SUMMARY OF CONCERNS IN RELATION TO THE PROPOSED NORTHCONNEX TUNNEL

This is an objection to many aspects of the proposed NorthConnex tunnel.

SECTION A: THE CONNECTIVITY OF NORTHCONNEX SOUTHERN VENTILATION FACILITY AT THE SOUTHERN INTERCHANGE, THE SOUTHBOUND TUNNEL IN PARTICULAR

MOTORWAY OPERATIONS COMPLEX - SOUTHERN VENTILATION FACILITY - SECTIONS
M1-M2-5000-DR-JD-0525

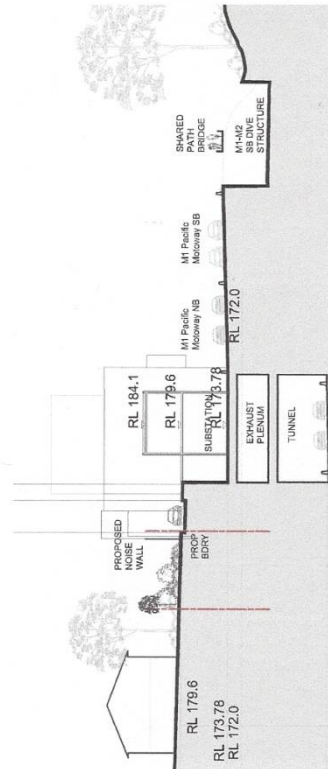
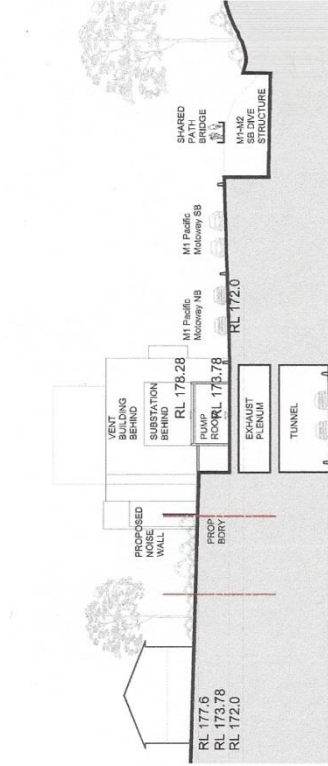
5. *EIS Volume 4, Technical working papers - Urban Design, 6.0 Operational Ancillary Facilities*
EIS Page 99 there is the diagram "Motorway Operations Complex – Southern Ventilation Facility – sections. *Page 10 below* The diagram has the cryptic label "Connection to tunnel TBC". What does TBC stand for? To be considered? Why is tunnel singular? Which tunnel is the diagram referring to northbound or southbound? There is no diagram showing any connection from the Southern Interchange ventilation facility to either the northbound or the southbound tunnel in any way AND YET

- Diagrams need to be provided showing the inter-relation between the shaft, the ventilation outlet and the motorway operations centre with a clear description of what is to be constructed and how it will operate.
- The community needs irrefutable evidence that the polluted air from the southbound tunnel exit portals will not be allowed to flow like an invisible sewer through West Pennant Hills, North Rocks, Carlingford and Beecroft.

M1-M2-5000-DR-UD-0550
NORTHERN VENTILATION FACILITY - CROSS SECTIONS

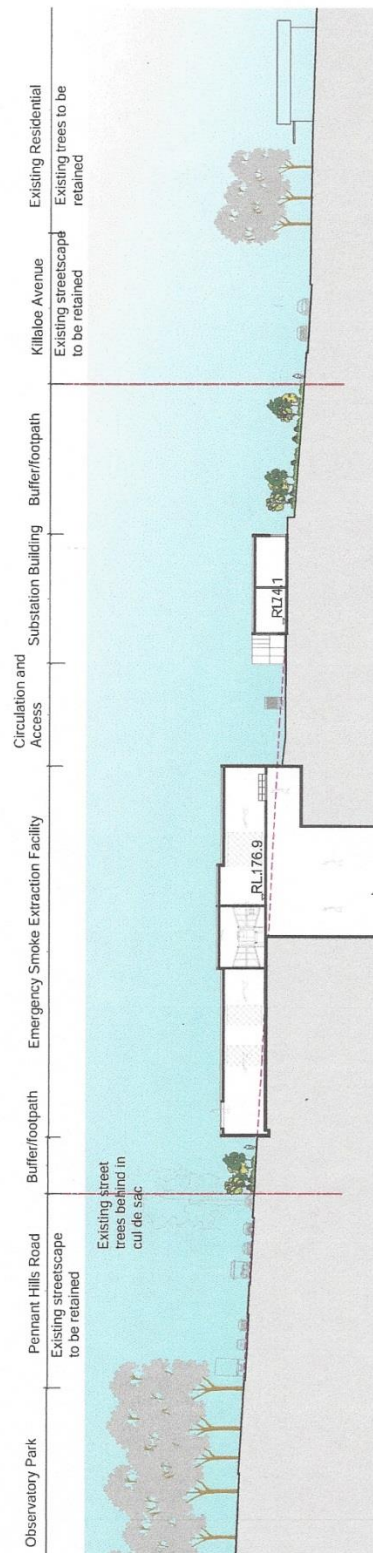
EIS page 135 *Page 11 below* there is a very explicit diagram showing the *Northern Ventilation Facility – cross section*.

EIS page 134 *Page 12 below* there is a very explicit diagram showing the *Northern Ventilation Facility – long section*.

Why are there no comparable diagrams for the Southern Interchange and the Southern Ventilation facility?
